TECO's Response to OPC's Third Set of
Interrogatories Nos. 51-149

**TAMPA ELECTRIC COMPANY
DOCKET NO. 20220048-EI
OPC'S THIRD SET OF
INTERROGATORIES
INTERROGATORY NO. 51
BATES PAGE: 1
FILED: MAY 25, 2022**

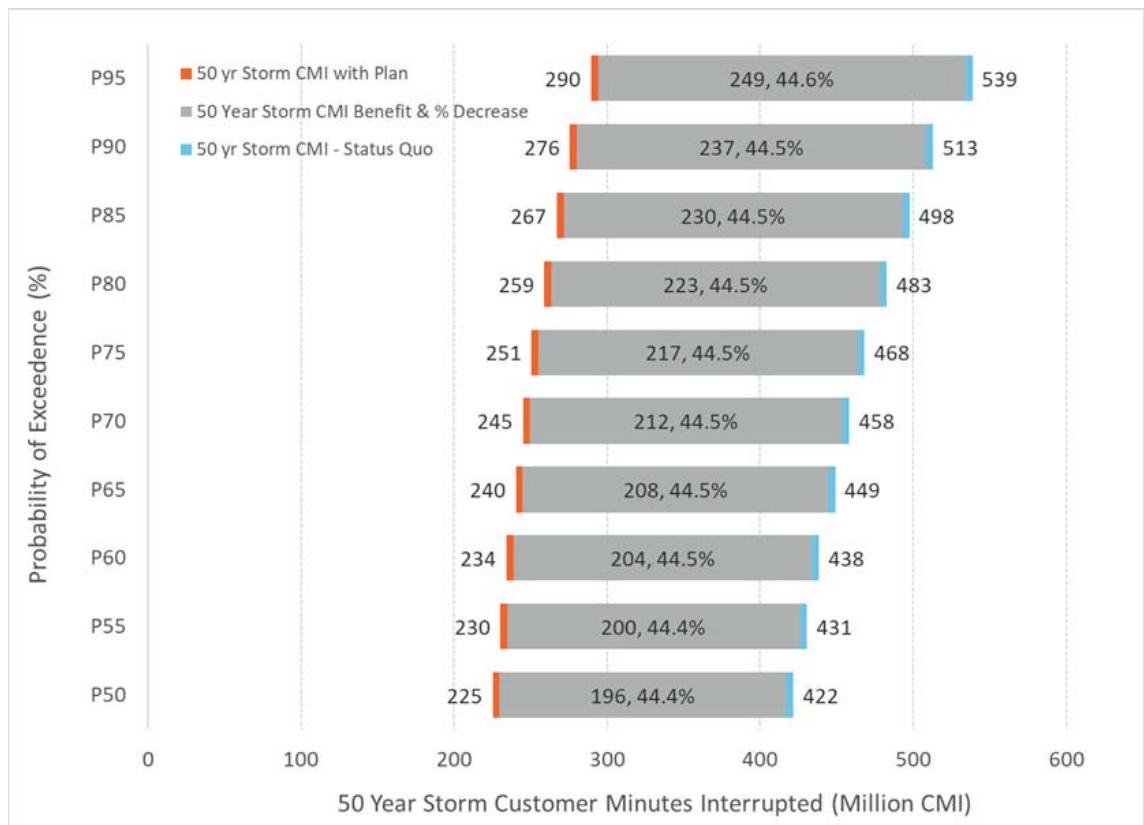
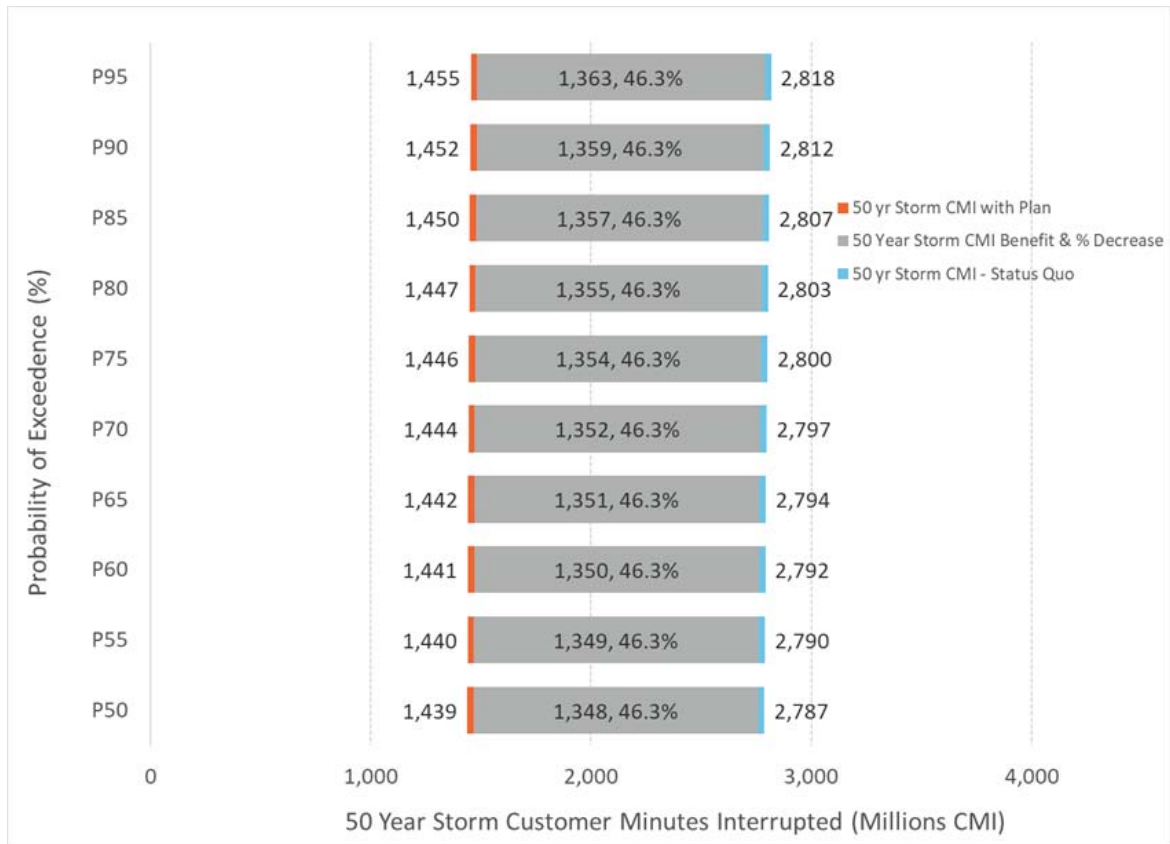
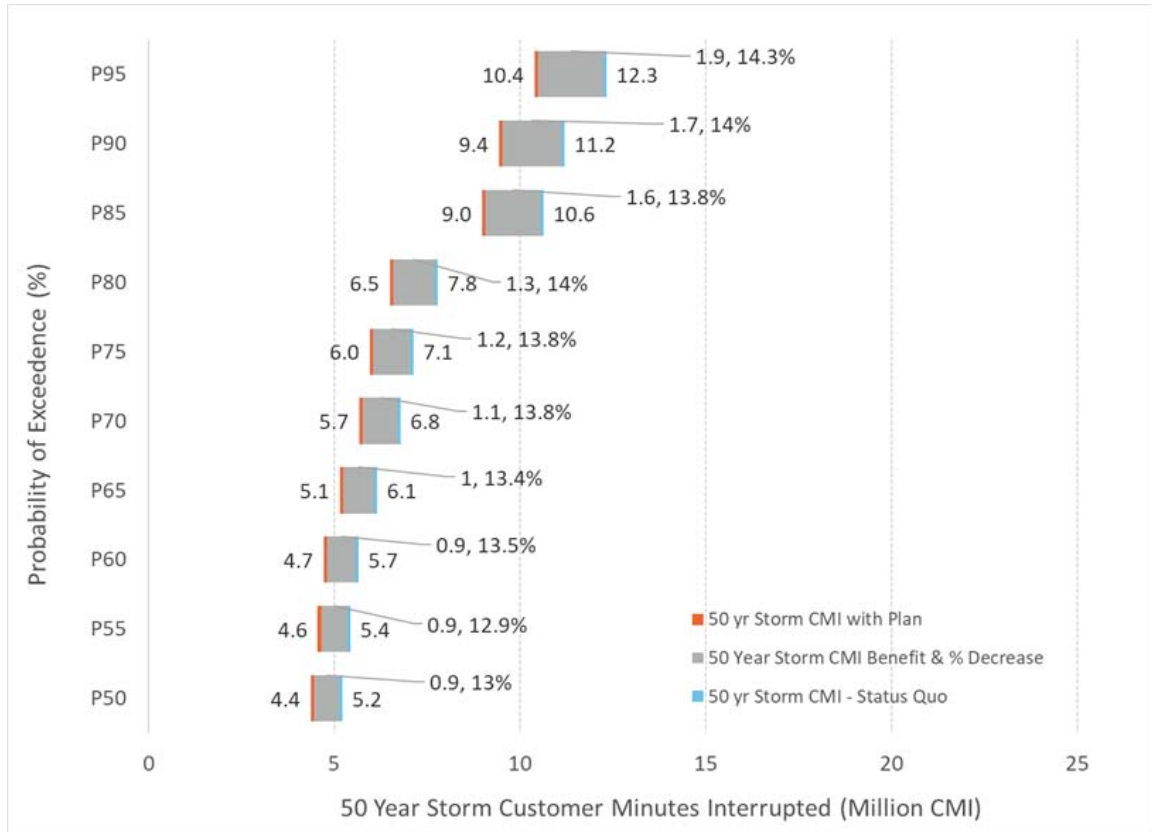
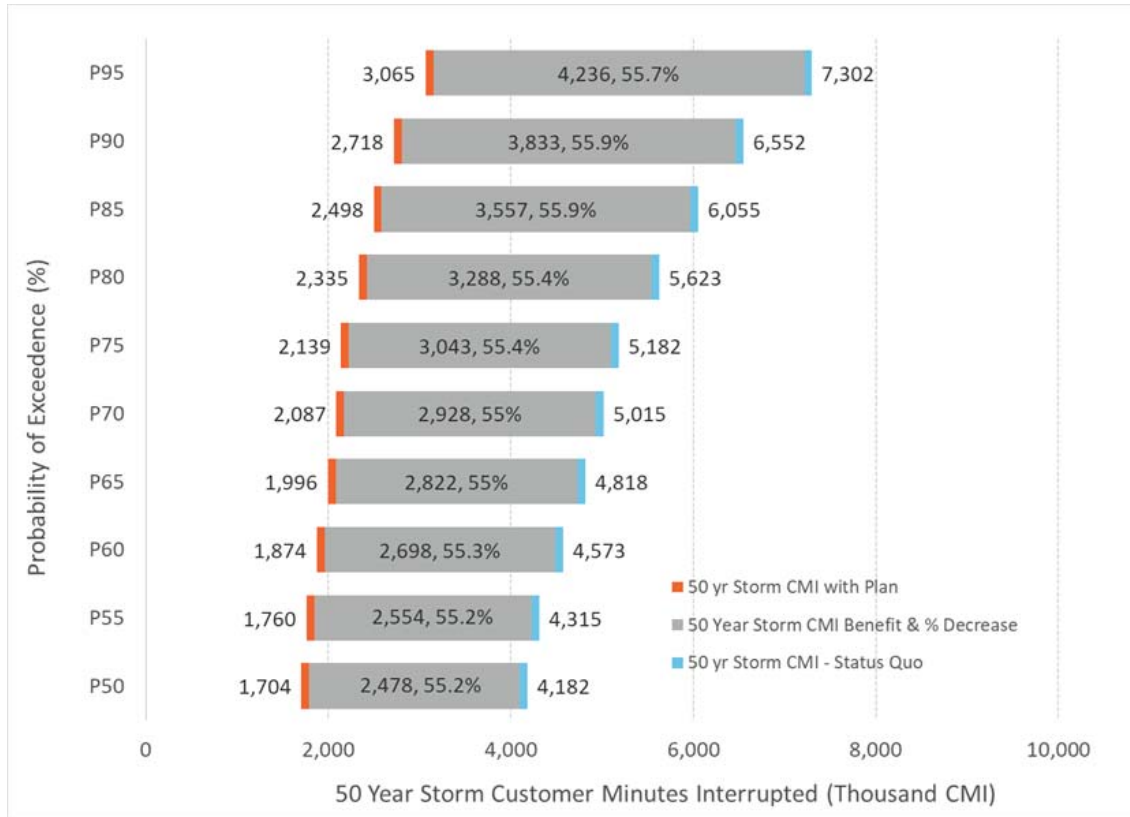
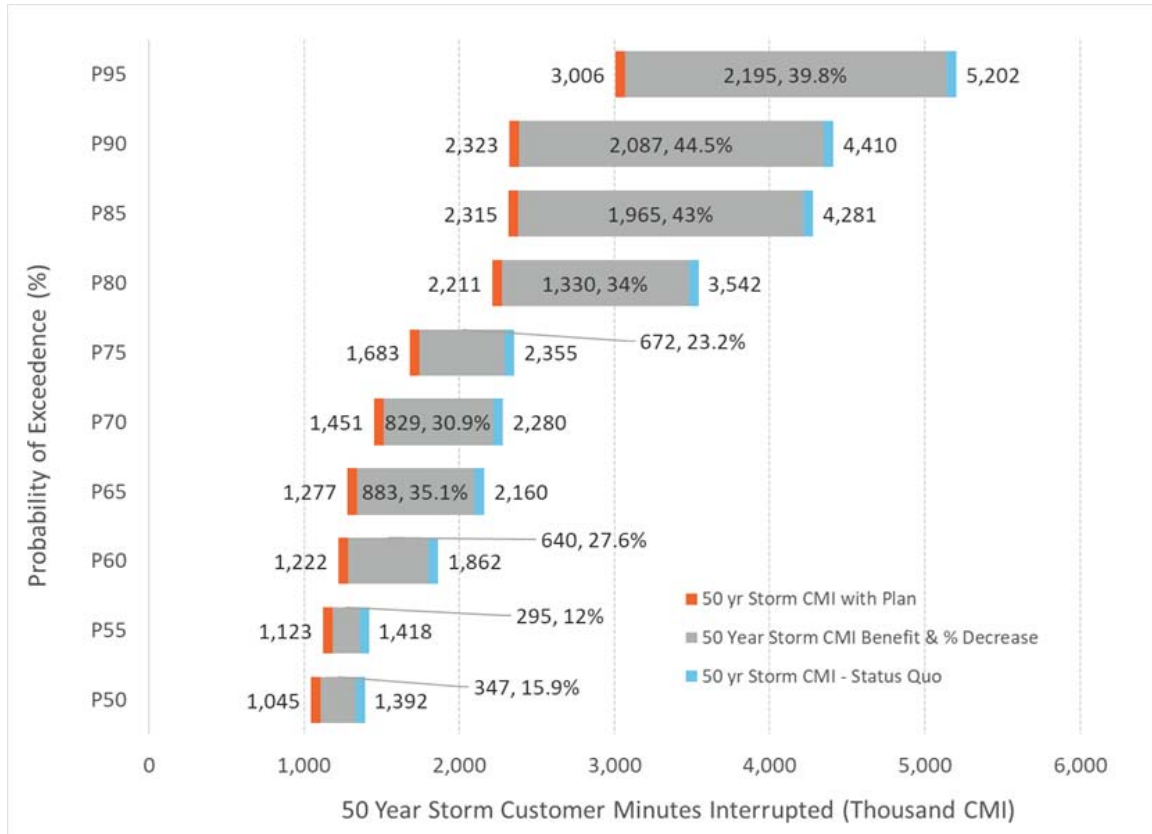
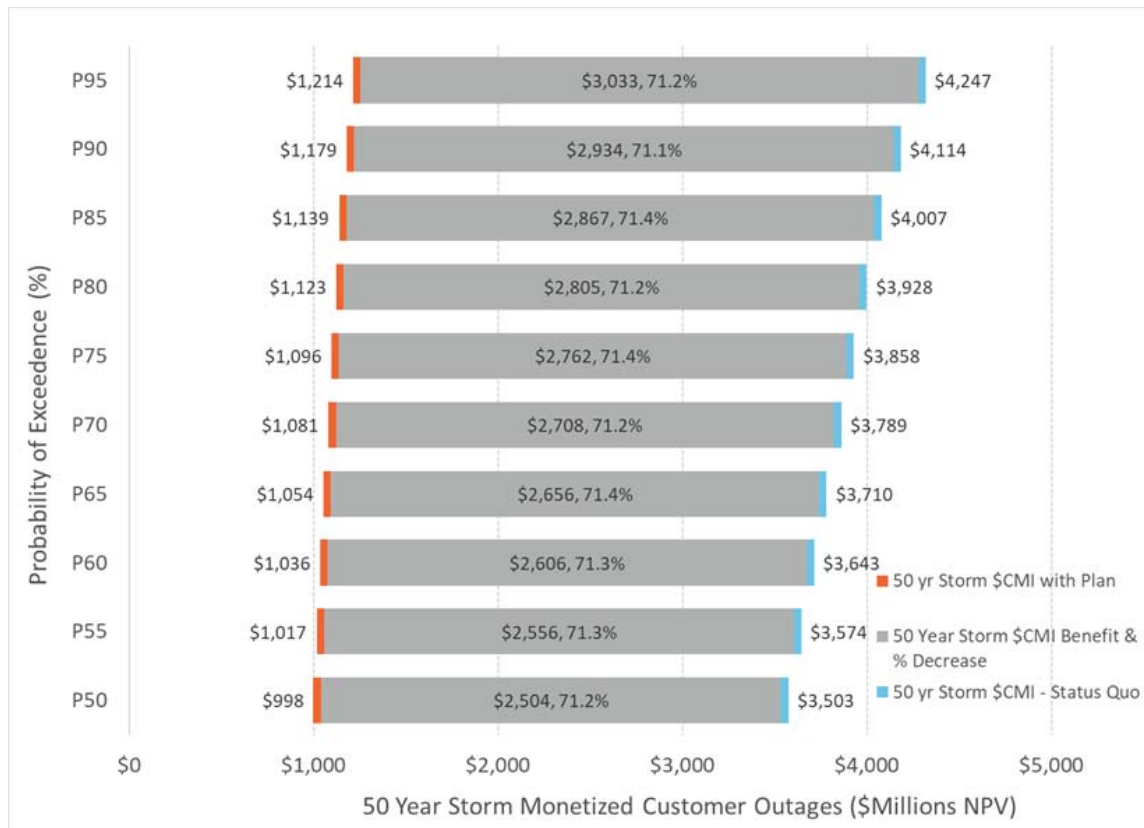
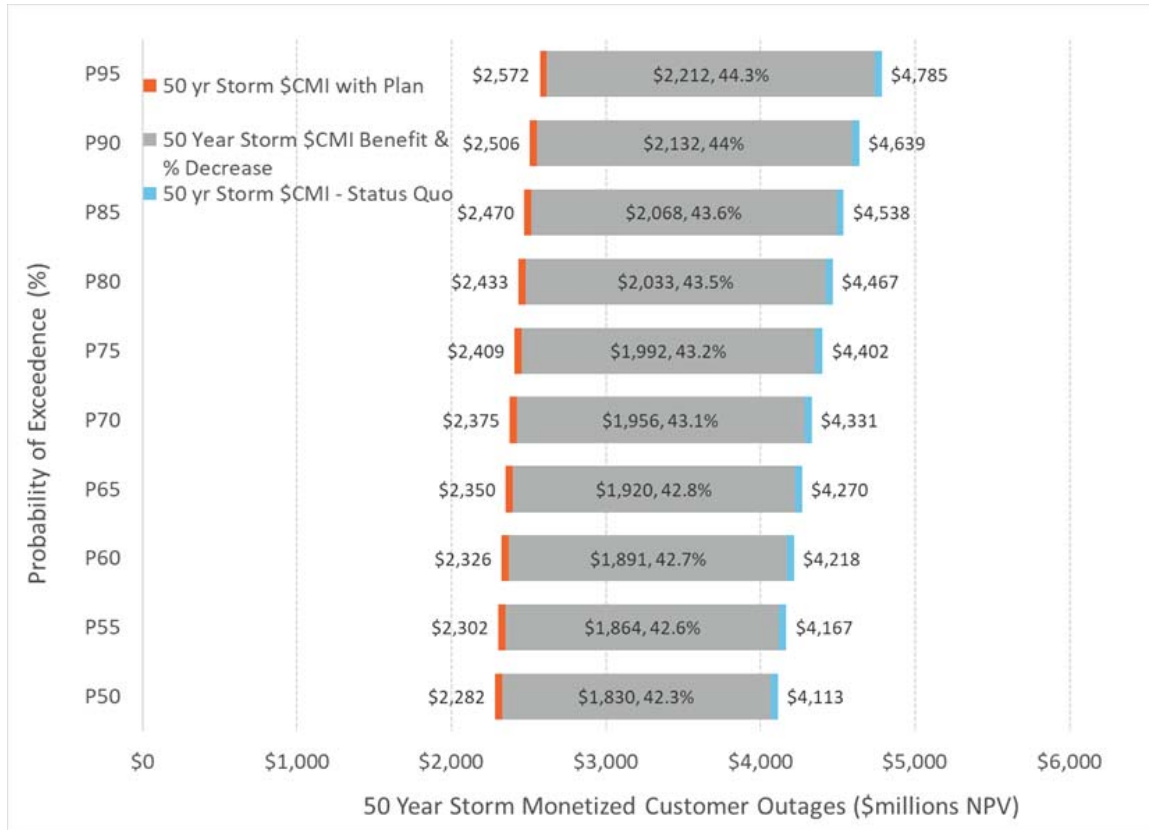
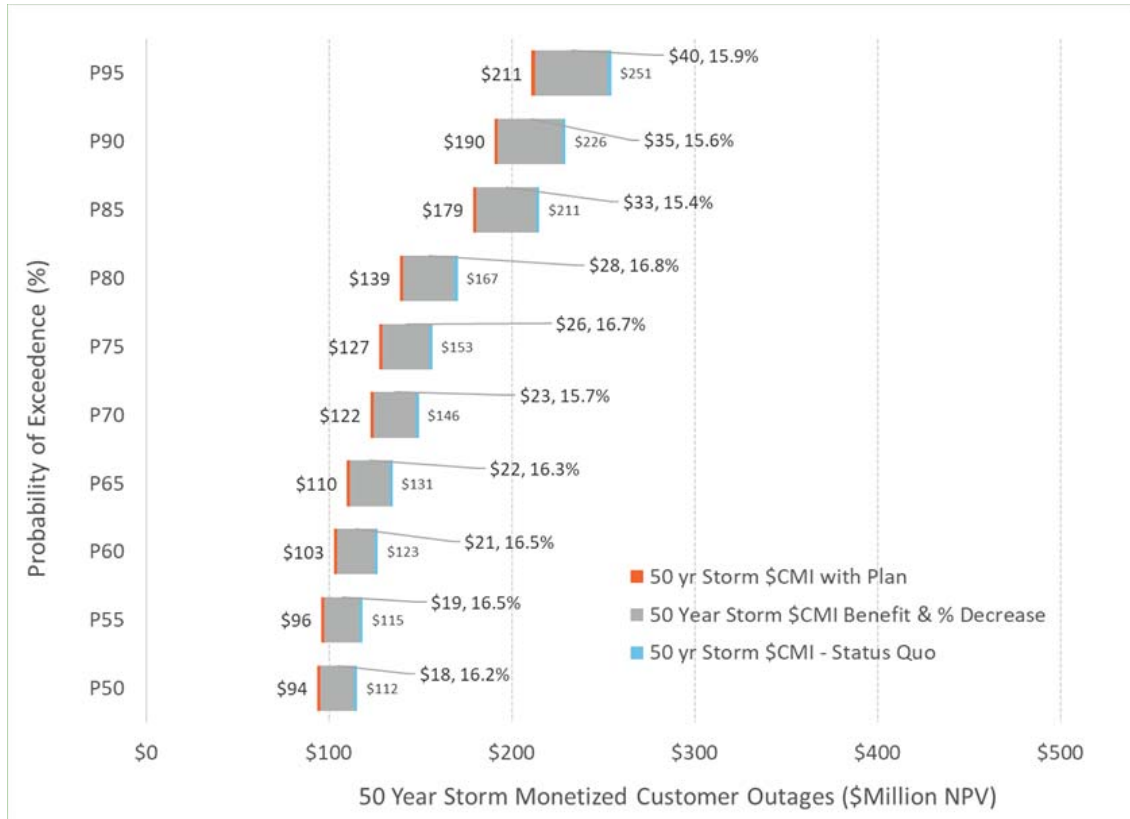
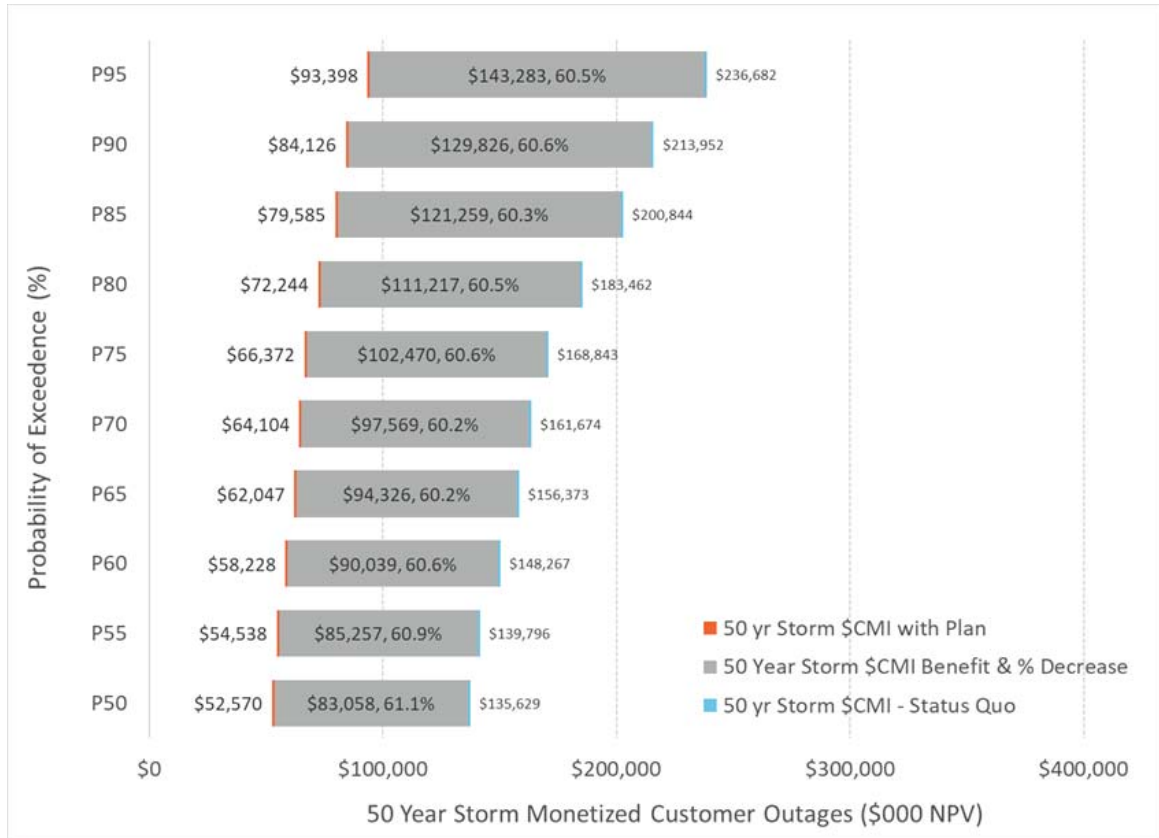
- a. Provide actual costs in reduction in restoration costs for storm protection program.
- b. Describe the term of reduction costs (annual, ten years, life of the assets, etc)
- c. Provided projected annual cost reduction for the next ten years.
- d. Provide actual customer minutes of interruption before improvements and after improvements.
- e. Describe the term of reduction costs (annual, ten years, life of the assets, etc)
- f. Provided projected annual cost reduction for the next ten years.

d. For each of the programs, the following figures shows:

The percentage in the grey areas map to the values in the table on page 71 of 78 references in the question. Adding all these figures together produces the results for the entire plan.

The following figures convert the CMI values to dollars using the DOE ICE Calculator and described in the plan.
